City of Mississauga Department Comments

Date Finalized: 2021-09-08 File(s): A367.21

The applicant requests the Committee to approve a minor variance to allow an addition proposing a rear yard of 5.55m (approx. 18.21ft) whereas By-law 0225-2007, as amended, requires a minimum rear yard of 7.50m (approx. 24.60ft) in this instance.

Property Address: 3983 Pondview Way

Appendix 1 – Transportation and Works Comments

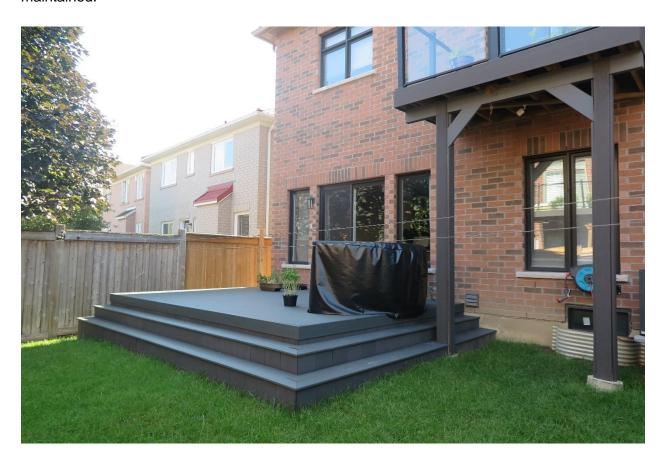
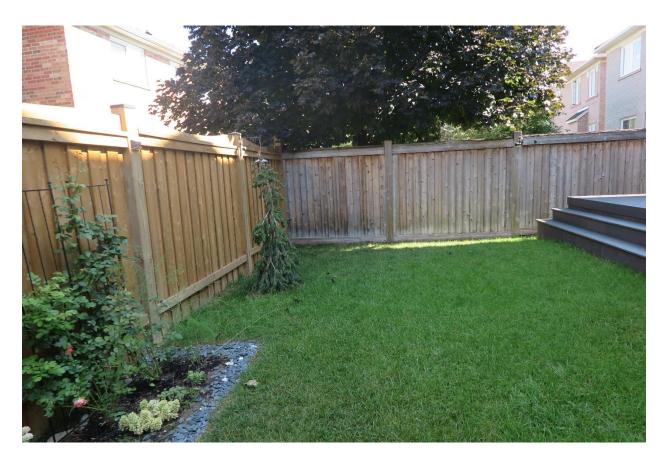
We are noting for Committee's information that any Transportation and Works Department concerns/requirements for the proposed addition will be addressed through the Building Permit Process. From our site inspection of the property we note that we do not foresee any drainage related concerns with the addition provided the existing grading and drainage pattern be maintained.
